PROJECT REFERENCE NO.	UC-43
DESIGNED BY:	AMH
DRAWN BY:	AMH/AB
CHECKED BY:	AMH
APPROVED BY:	MWF
REVISED:	
NORTH CAROLINA DEPARTMENT OF TRANSPORTATION	
UTILITIES ENGINEERING SEC. PHONE: (919) 707-6690 FAX: (919) 250-4151

UTILITY CONSTRUCTION

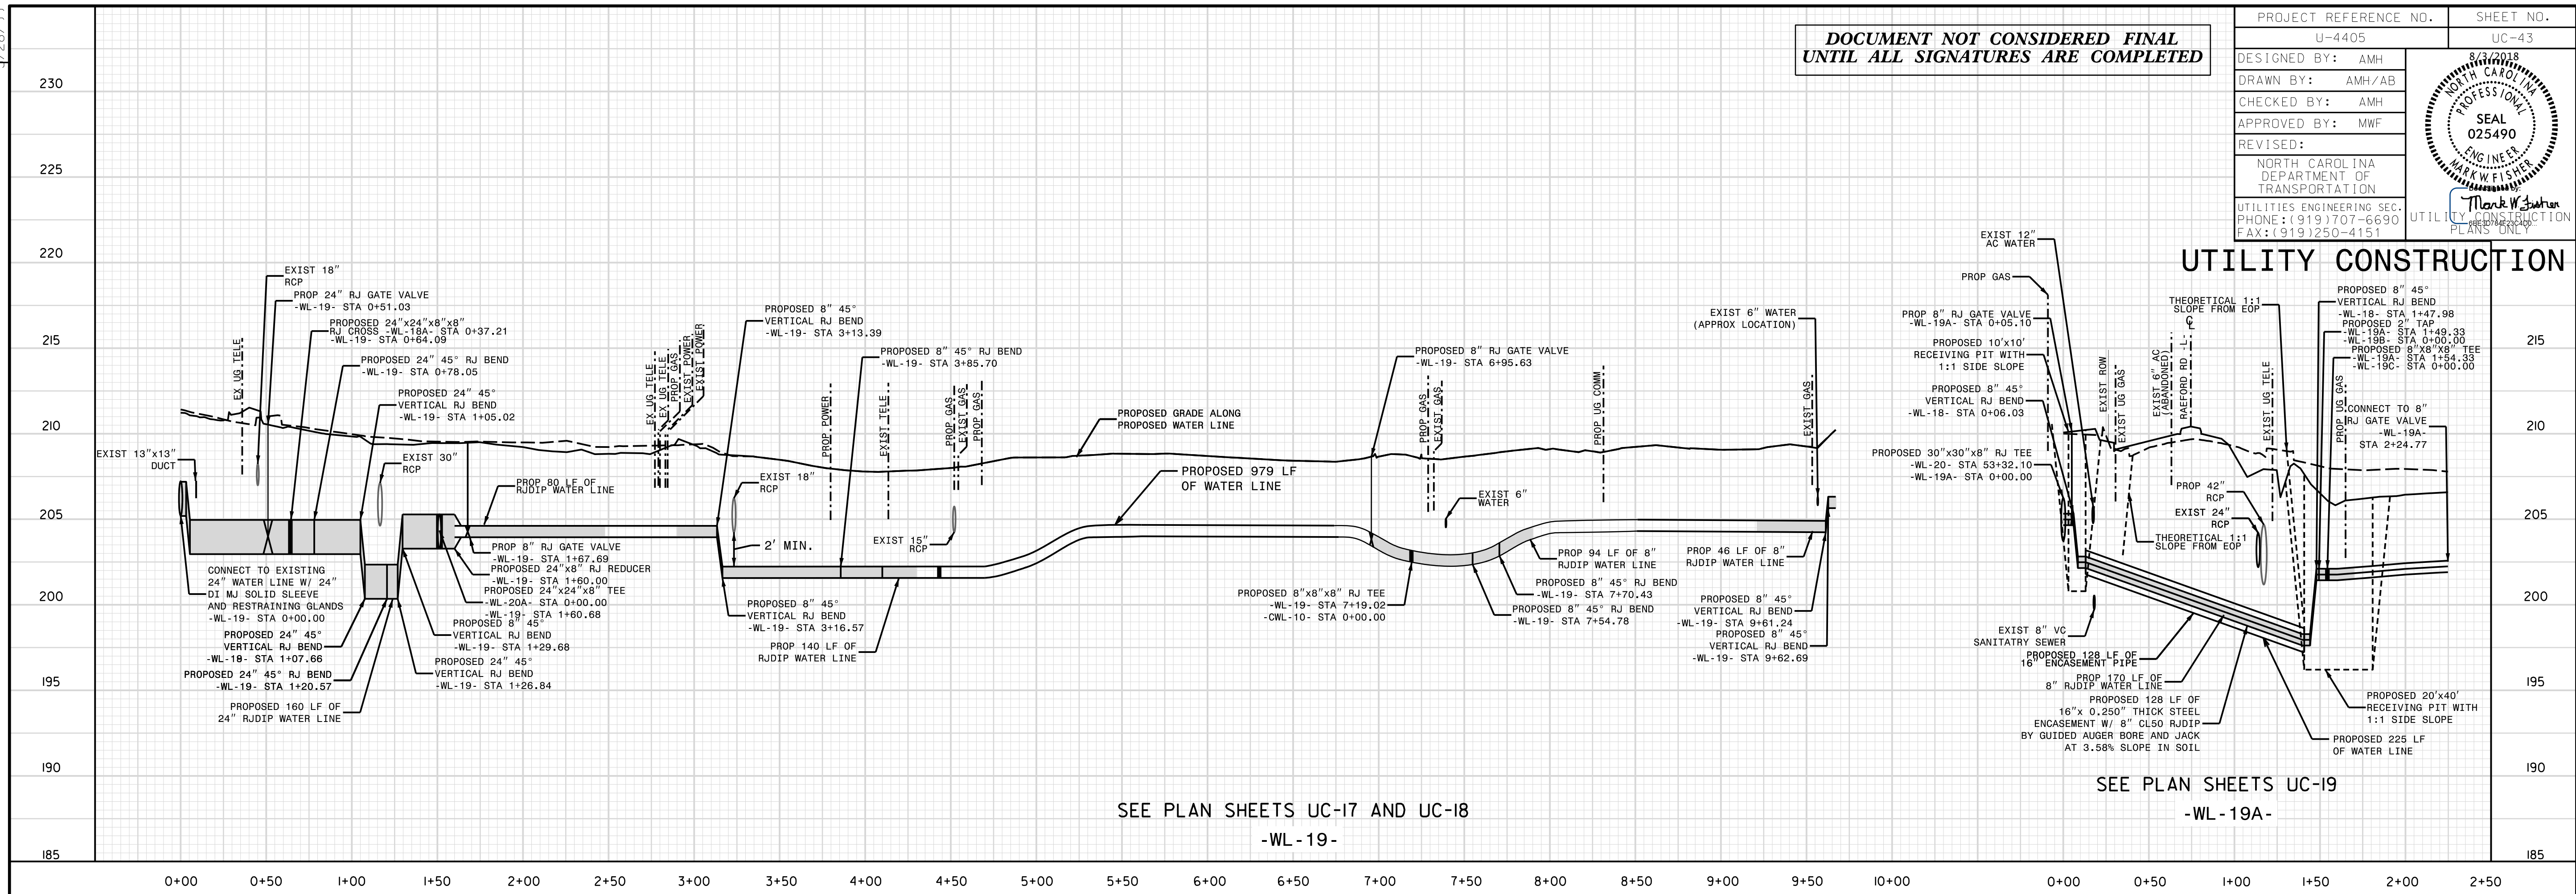
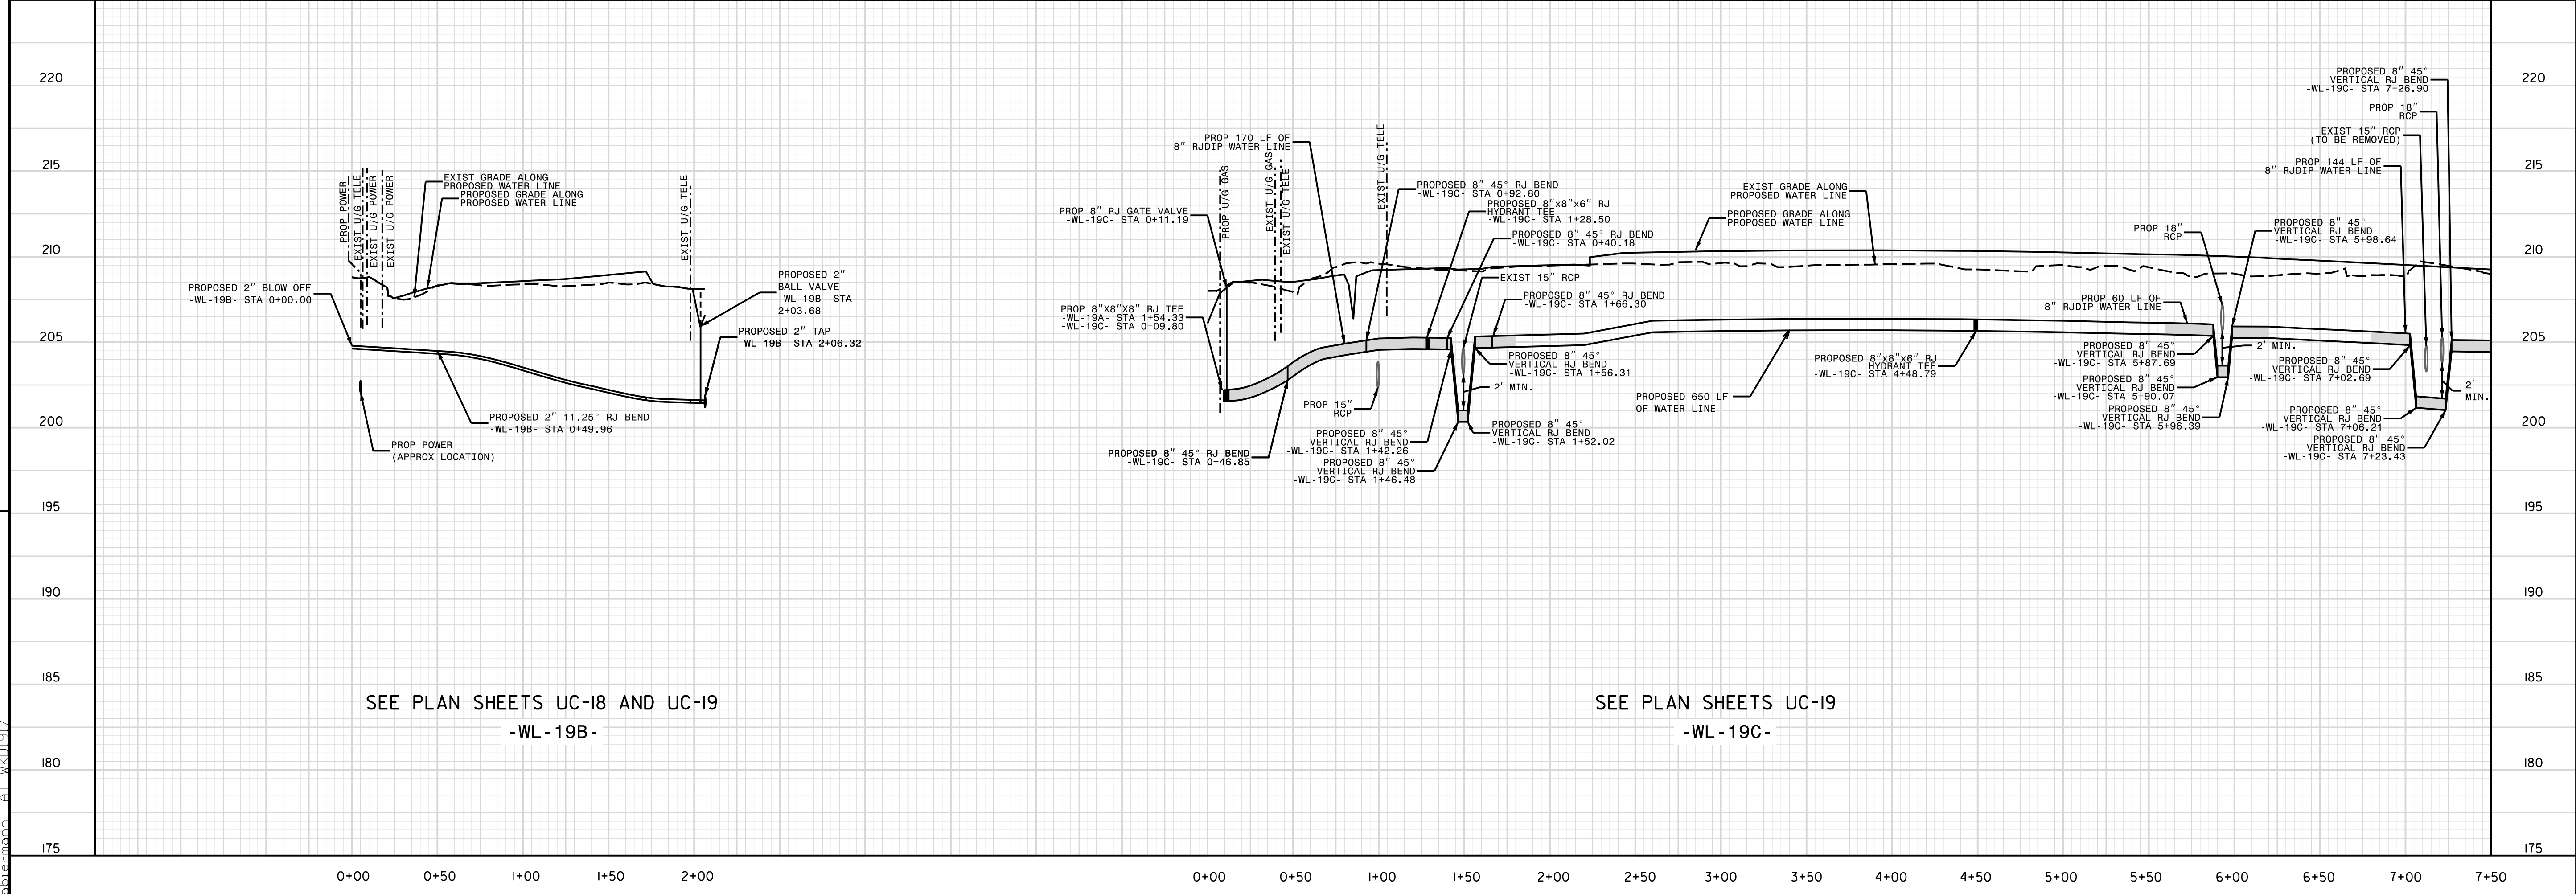
UTILITY REV. - JULY 23, 2018 - ADDED 80 LF OF RJDIP TO -WL-19- AT STA 1HTO
 - SHIFTED PROP VALVE ON -WL-19C- FROM STA 449 TO STA 49+50
